Item No. 15.5.1
Halifax Regional Council
January 11, 2022

SUBJECT: **Cases 23746 & 22896: MPS and Development Agreement Amendments for Seton Ridge - Bedford Highway, Seton Road & Lacewood Drive, Halifax**

Item No. 13.1.5
Halifax and West Community Council
December 15, 2021

SUBJECT: **Cases 23746 & 22896: MPS and Development Agreement Amendments for Seton Ridge - Bedford Highway, Seton Road & Lacewood Drive, Halifax**

Bedford Highway Secondary Planning Strategy
Map 9Df – Seton Ridge Neighbourhood Plan

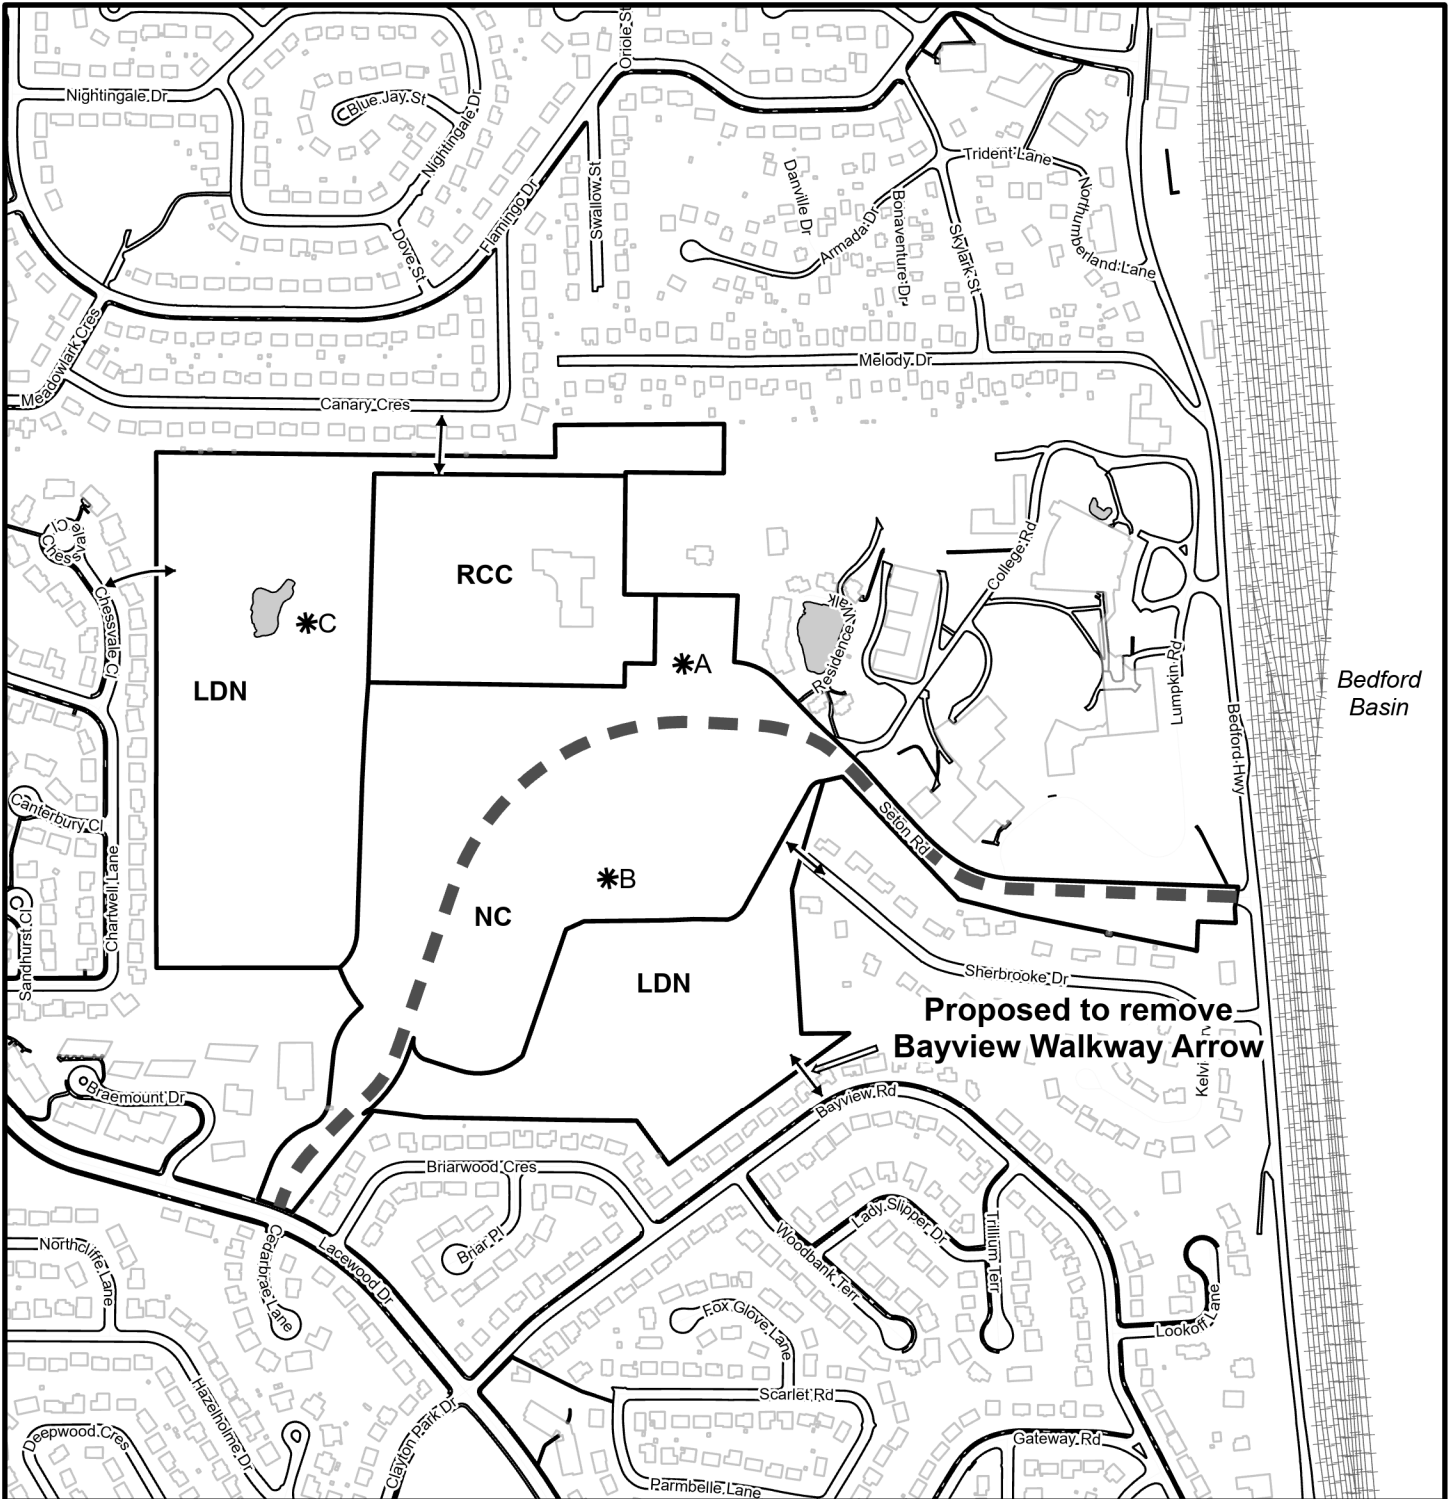
1. Map 9Df of Section VIII (Bedford Highway Secondary Planning Strategy) shall be amended by deleting the arrow which denotes the walkway connection between the Seton Ridge lands and Bayview Road, Halifax, as shown on Schedule A attached hereto.

Proposed to remove Bayview Walkway Arrow

Schedule C2A - Site Plan

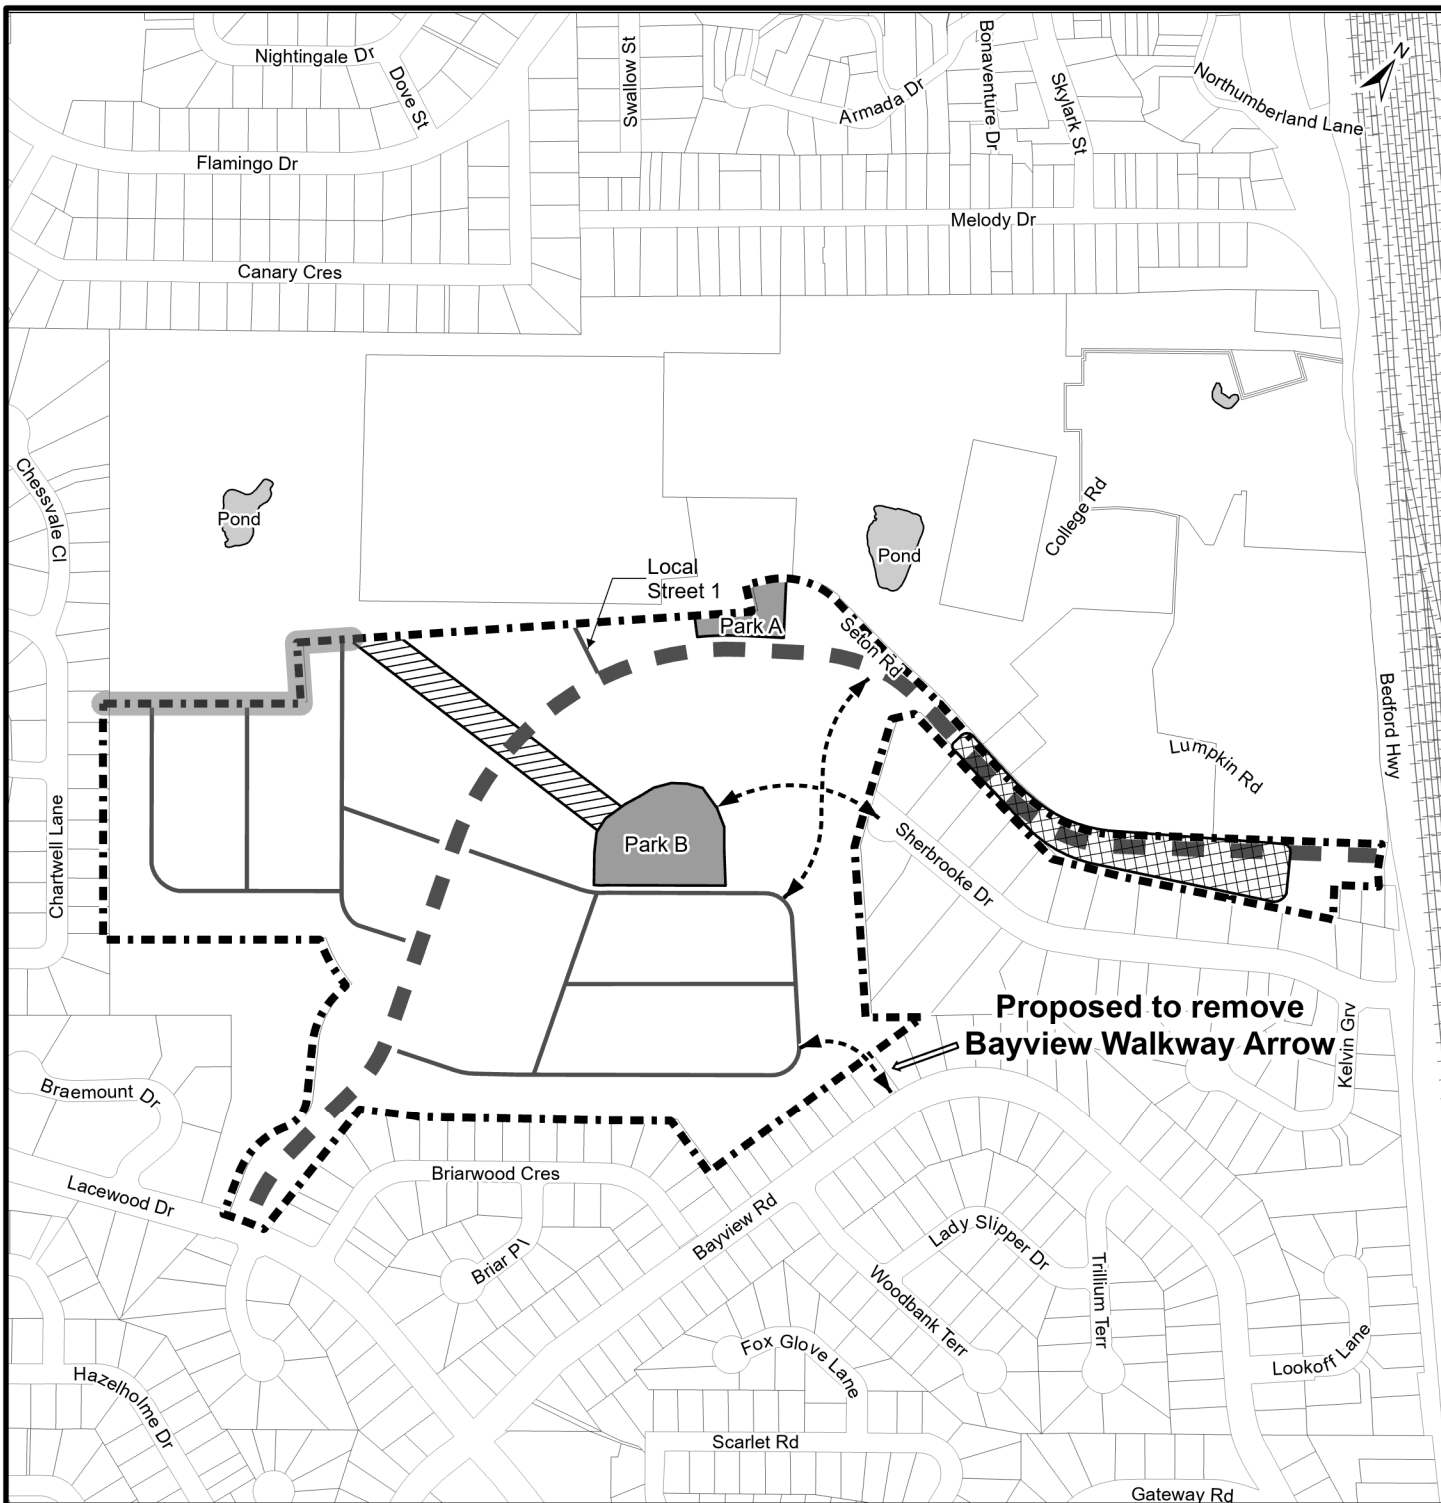
- Amend Schedule C2 of the development agreement to remove the subject walkway linking to Bayview Road. While the existing HRM-owned parcel located on Bayview Road, between civic numbers 77 and 79, was intended as a future walkway, it is too narrow and too steep to allow for the construction of a walkway to HRM specifications. The proposal to omit this walkway on Bayview Drive cannot be considered without an amendment to the Halifax MPS noted above, as the proposed walkways are shown on Map 9Df. However, the land parcel may be necessary for water service purposes, which will be confirmed through the final subdivision process.
